Version: 1.0 – LBL-0623 Release Date: 7th of October

This Release Bulletin announces the release of the following Noxturnal software and CDs

- Noxturnal 7.2.1 40886
- Noxturnal US 7.2.1 40886

Figure 1: Device Properties for the LoFlo sensor when adding it to an Online Room

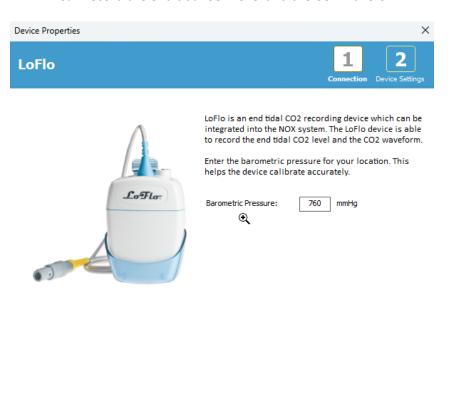
- Support for the Philips LoFlo EtCO₂
 - The Philips LoFlo sensor can now be added to online rooms In Noxturnal
 - The sensor connects to the USB port on the back of the Nox C1 Access Point
 - Can record the end tidal CO2 level and the CO2 waveform
